Groundwater Review Summary Form

Application # G- 18341

TO: Water Rights Section Date December 12, 2016
 FROM: Groundwater Section Aurora C Bouchier
 Reviewer's Name
 SUBJECT: Application G- 18341 Supersedes review of na
 Date of Review(s)

A. GENERAL INFORMATION: Applicant's Name: Clearlake Farms LLC County: Marion

Water-Level Trends in Nearby Wells

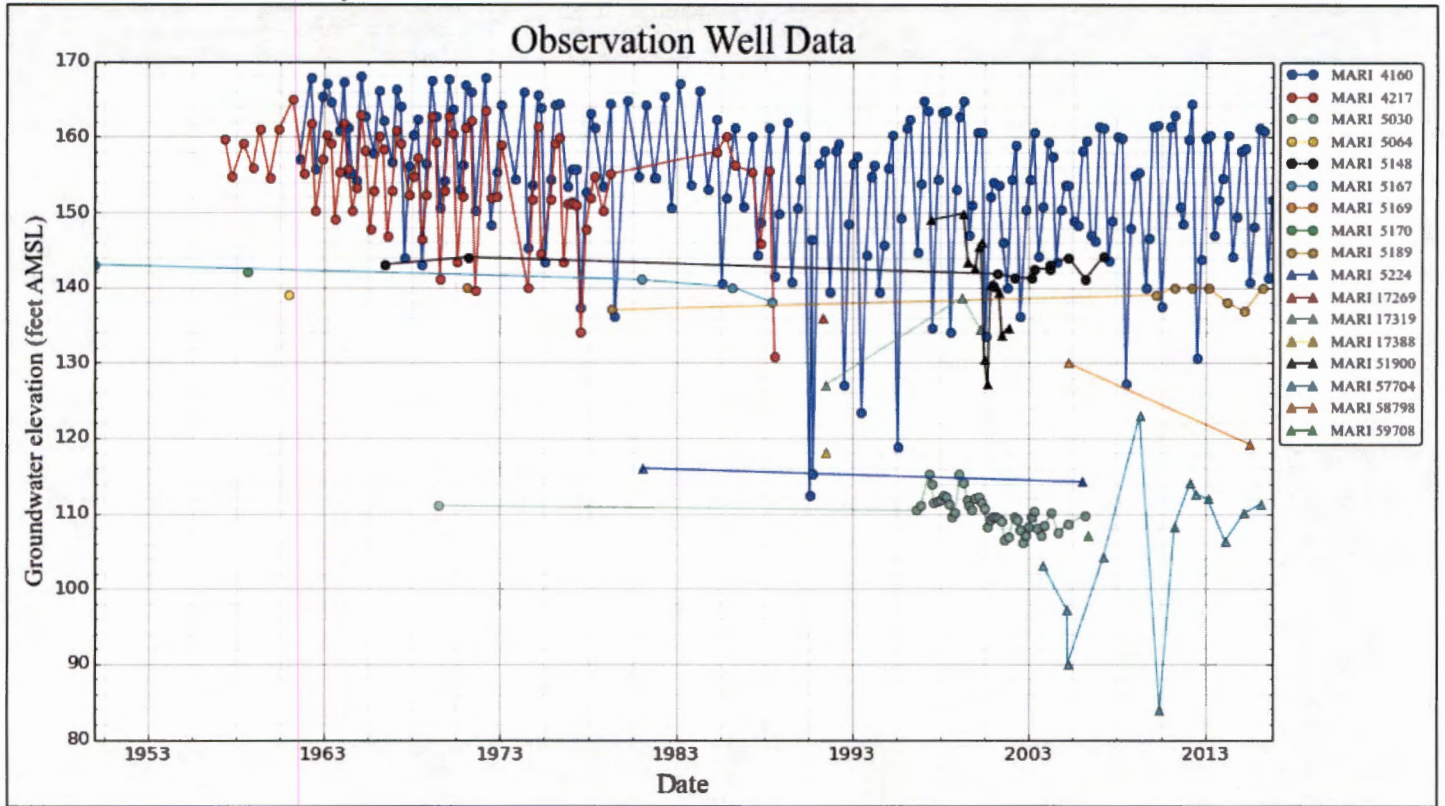
State Observation Well MARI 4160 is located just over 3 miles to the east-northeast, and State Observation Well MARI 4217 is located approximately 2 miles to the northeast. Water level measurements from the State Observation Wells and other nearby wells indicate relatively stable long-term trends (approximately 6 feet of water level decline between the early 1960's to present, with a seasonal variation of up to about 40 feet) for alluvial wells in the immediate area of the proposed well (see attached hydrograph). However, increased groundwater development in the area indicates a need for additional water-level monitoring.

Stream Interference Model Results

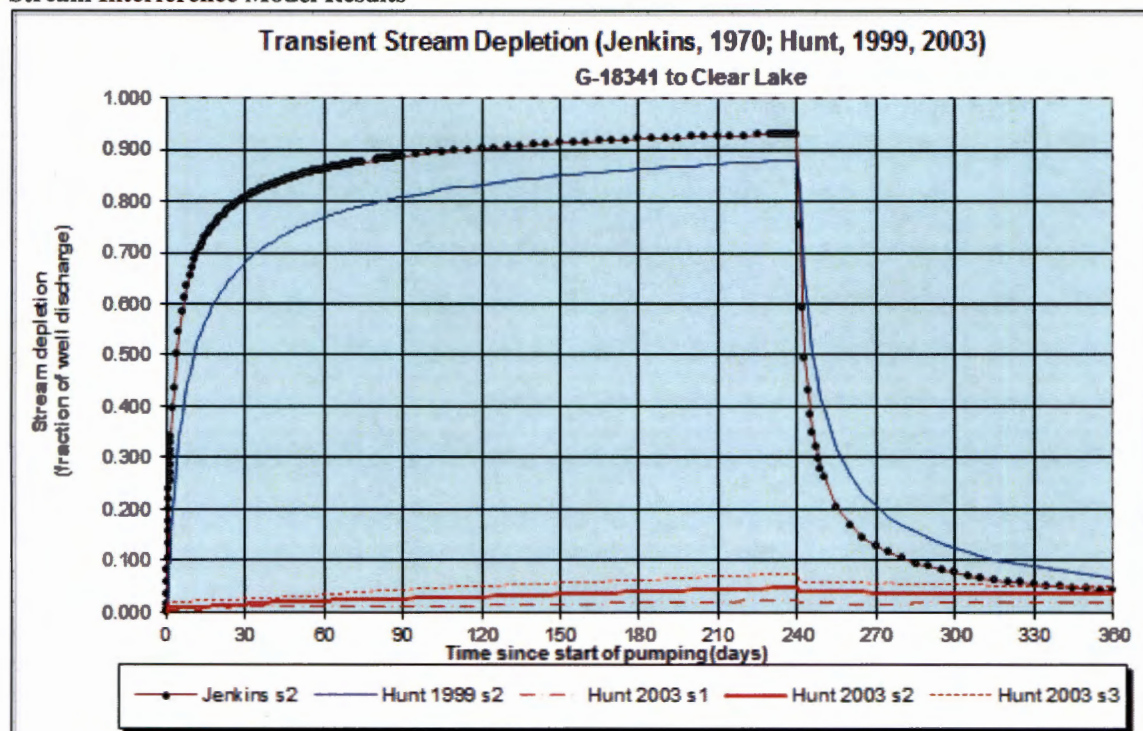
Comments: Interference to Clear Lake at 30 days was estimated using the Hunt 2003 model which simulates a confined aquifer as that is the case at the location of the well. Where the Willamette Silt has been eroded away (in the meander belt/flood plain of the Willamette River, which includes Clear Lake) it is likely the aquifer is not confined. However, a 3 feet aquitard thickness below the stream was included to represent a streambed clogging layer.

C6. **SW / GW Remarks and Conditions:** _____
The large distance between the wells and the hydraulically connected surface water bodies will likely result in an inefficient connection between the wells and the surface water bodies. However, stream depletion will increase over time.
